BEN LOMAND MOUNTIAN VILLAGE

PRELIMINARY PLAT

BEN LOMAND MOUNTAIN VILLAGE

PRELIMINARY PLAT

5 OF 23

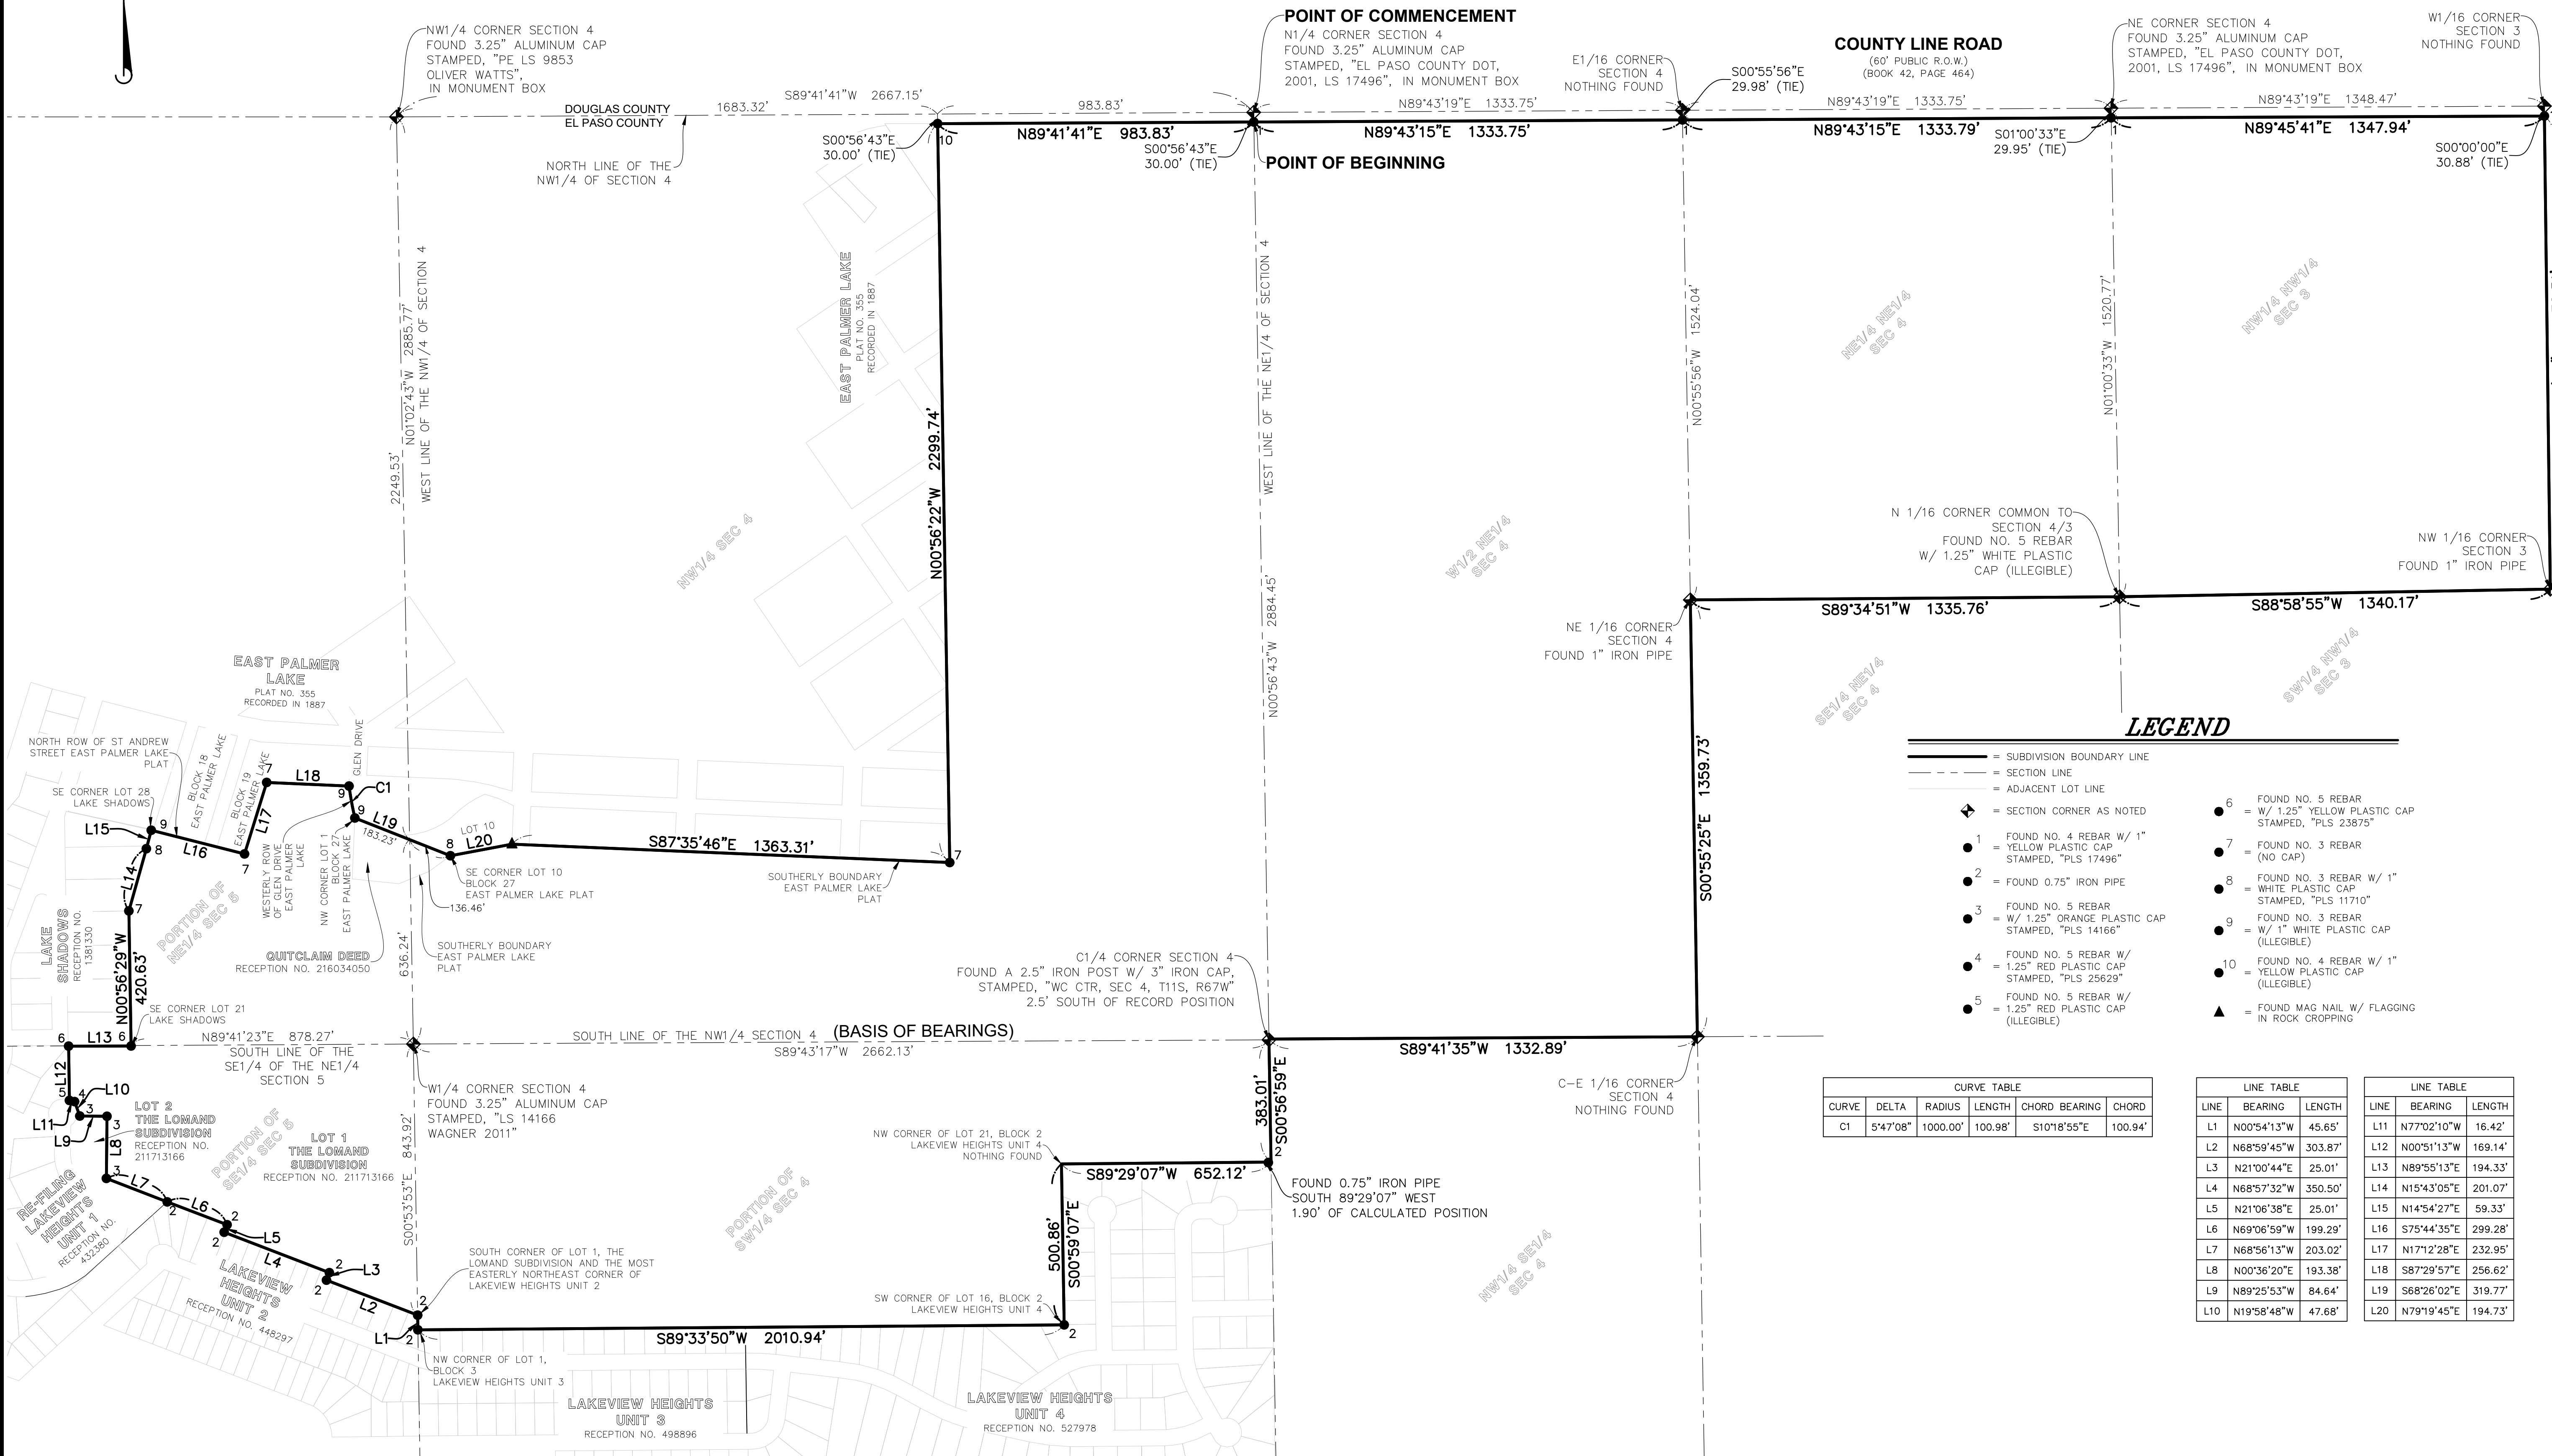
CORE will require the following language be added to the preliminary plan & plat notes.

No improvements that conflict with or interfere with construction, maintenance or access to utilities shall be placed within the utility easements. Prohibited improvements include, but are not limited to, permanent structures, buildings, counter-forts, decks, attached porches, attached stairs, window wells, air conditioning units, retaining walls/components and other objects that may interfere with the utility facilities or access, use and maintenance thereof.

The utility easements as shown hereon are hereby dedicated for public utilities, cable communication systems fiber and other purposes as shown hereon. The entities responsible for providing the utility services for which the easements are established are hereby granted the perpetual right of ingress and egress from and to adjacent properties for installation, maintenance and replacement of utility lines and related facilities

8 OF 23

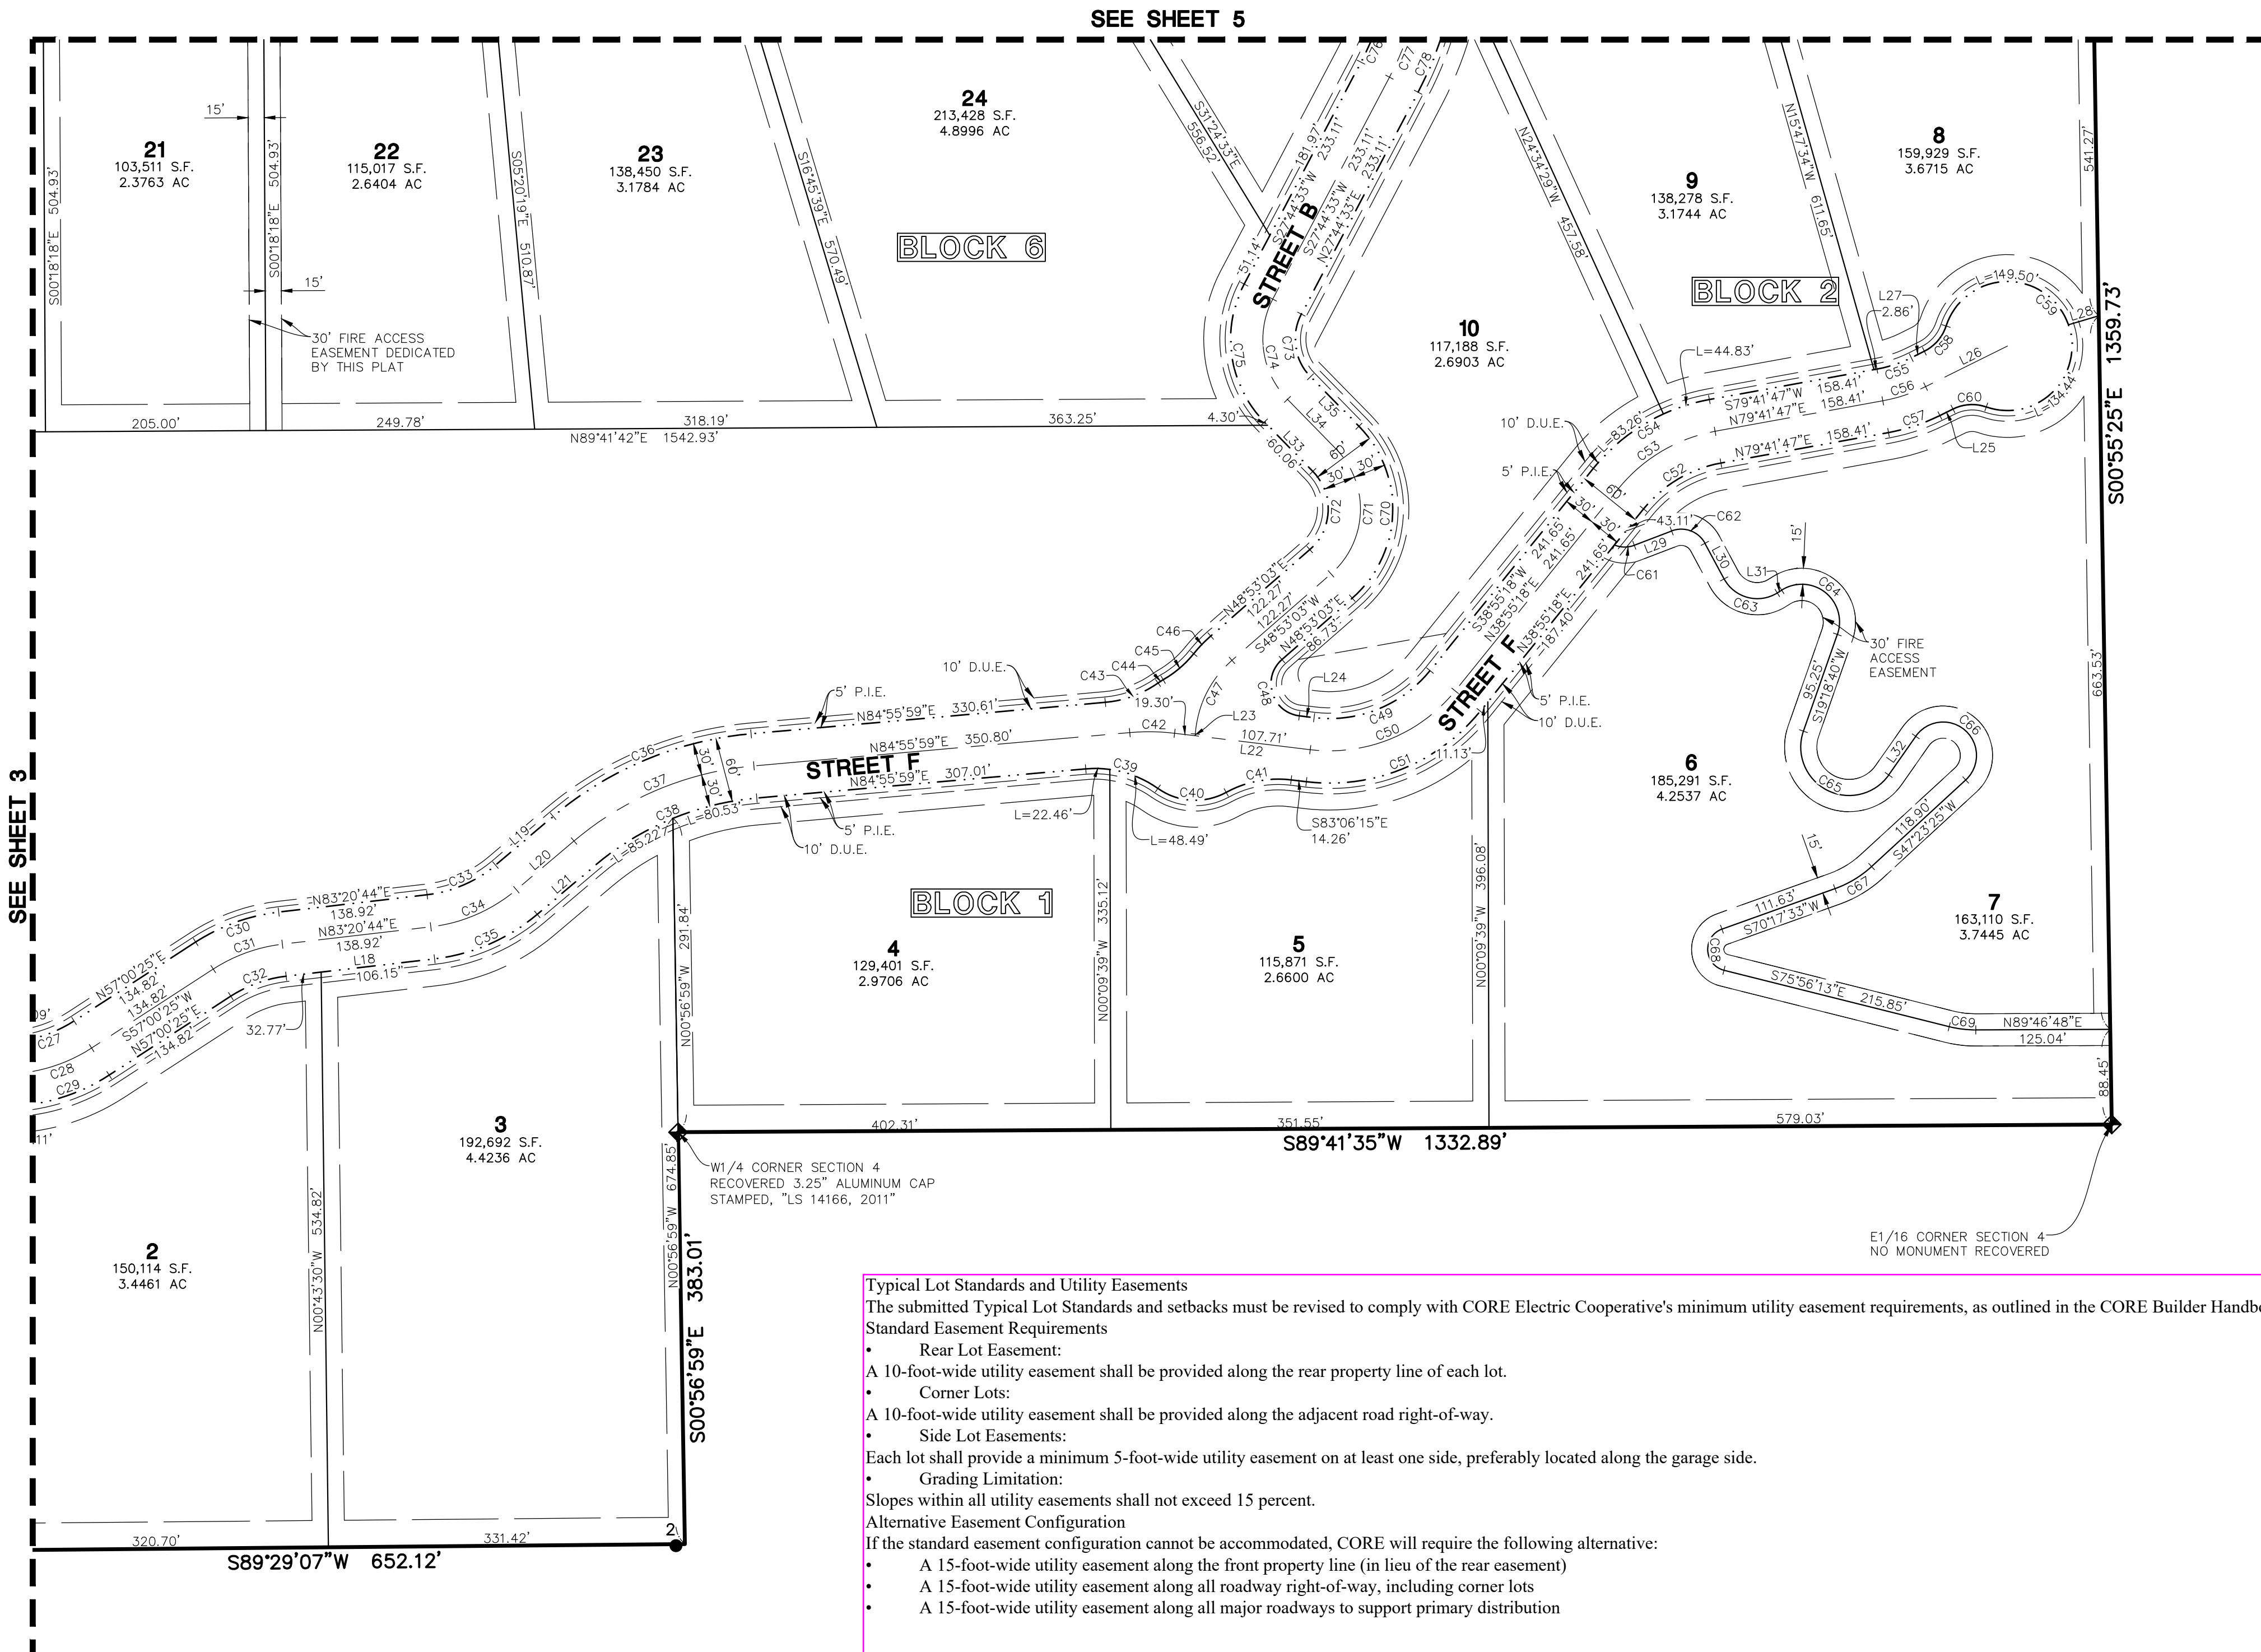
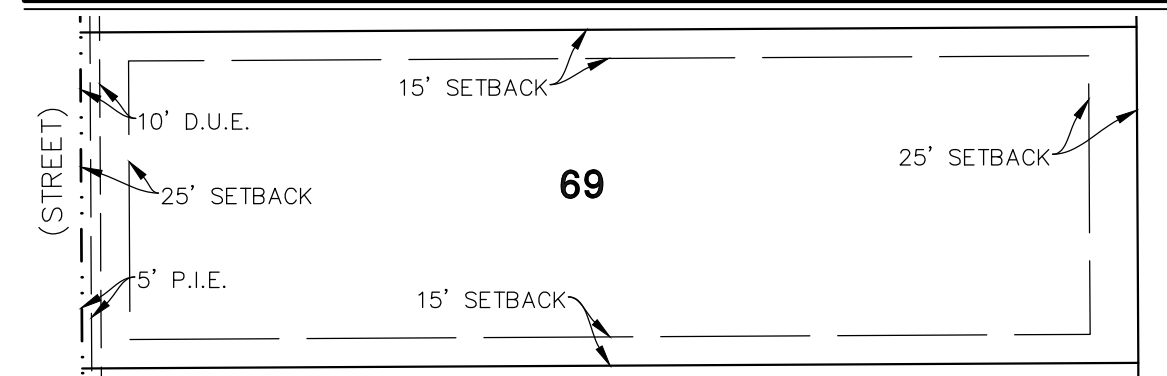
Typical Lot Standards and Utility Easements

The submitted Typical Lot Standards and setbacks must be revised to comply with CORE Electric Cooperative's minimum utility easement requirements, as outlined in the CORE Builder Handbook.

- Rear Lot Easement:
 - A 10-foot-wide utility easement shall be provided along the rear property line of each lot.
- Corner Lots:
 - A 10-foot-wide utility easement shall be provided along the adjacent road right-of-way.
- Side Lot Easements:
 - Each lot shall provide a minimum 5-foot-wide utility easement on at least one side, preferably located along the garage side.
- Grading Limitation:
 - Slopes within all utility easements shall not exceed 15 percent.

Alternative Easement Configuration

If the standard easement configuration cannot be accommodated, CORE will require the following alternative:

- A 15-foot-wide utility easement along the front property line (in lieu of the rear easement)
- A 15-foot-wide utility easement along all roadway right-of-way, including corner lots
- A 15-foot-wide utility easement along all major roadways to support primary distribution
